Sydney Central City Planning Panel
Section 4.15 Assessment Report
Environmental Planning & Assessment Act 1979

Key Details	
Panel reference no.	PPSSCC-563
DA no.	DA/327/2024
Local government area (LGA)	City of Parramatta
Proposed development	47-storey mixed-use building fronting Phillip Street comprising retail premises, office premises and shop-top housing units (Build-to-Rent); 30-storey mixed-use building fronting George Street comprising retail premises, office premises; basement car parking, public through-site links; landscaping; following demolition of existing 'Octagon' office building, earthworks, tree removal; and Stratum subdivision. The application will be determined by the Sydney Central City Planning Panel.
Street address	110 George Street, Parramatta
Applicant/Owner	The Trustee for 110 George Street Unit Trust
Date of lodgement	19 June 2024
Total number of submissions	One (1)
Number of unique objections	One (1)
Recommendation	Approval (Deferred Commencement)
Regional Development Criteria	Development specified in Schedule 6 Clause 2 (General development over \$30 million) of the <i>State Environmental Planning Policy (Planning Systems) 2021</i> declared to be regiona

Figure 22 Low-rise Floorplates Type 1 (left) and 2 (right)

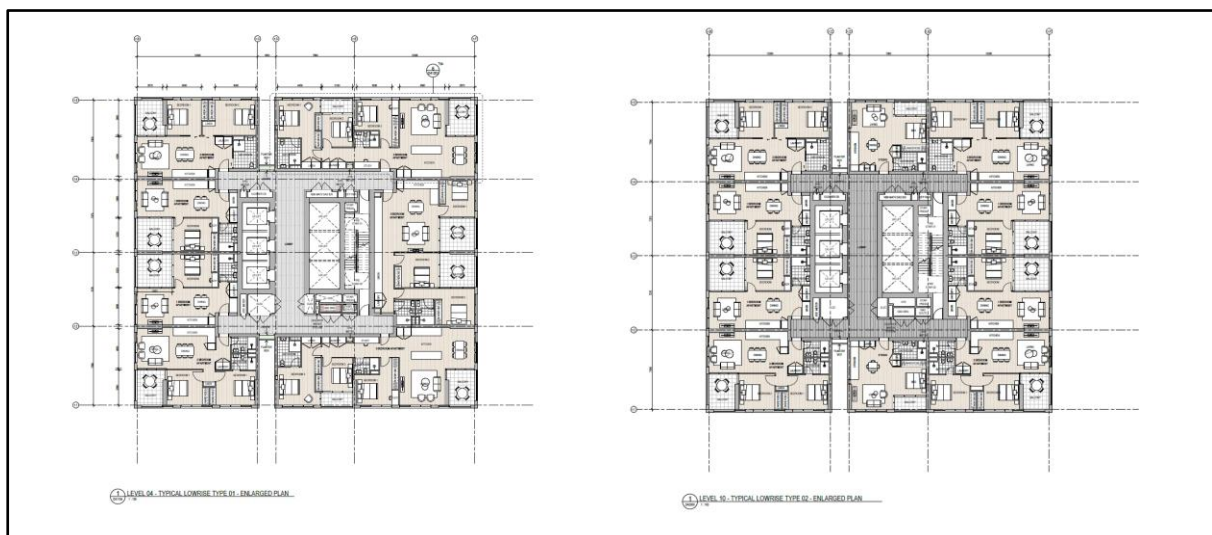
To remedy the inconsistency between the proposed dwelling mix and the dwelling mix requirements of the *Parramatta Development Control Plan 2023*, the following condition of consent is recommended to be imposed in the event of the application's approval which requires the use of a floorplate with additional 3-bedroom units between levels 10 and 13 (inclusive).

1. *The architectural drawings prepared by Hassall shall be amended to substitute 'Typical Low-Rise Type 2' floorplate (noted on drawing no. DA1201A) with 'Typical Low-Rise Type 1' floorplate (noted on drawing no. DA1201) between levels 10 and 13 (inclusive) for the shop-top housing/residential flat building. A copy of amended architectural drawings shall be submitted to Council's Development and Traffic Services ('DTSU') Manager for approval prior to the activation of this consent.*

Condition reason: To ensure an appropriate quantity of three-bedroom units are provided in the development to meet the residential needs of the community.

The imposition of the above condition would adjust the dwelling mix within the residential building as follows.

Whilst the condition would not result in the development achieving full compliance with the *Parramatta Development Control Plan 2023*, the adjustment to the dwelling mix would result in compliance with the minimum three-bedroom unit requirements and partially address the three-bedroom unit shortage in Parramatta. Approximately 88.31% of units provided will be studio, one-bedroom, and two-bedroom units which will contribute to meeting the needs of smaller households.
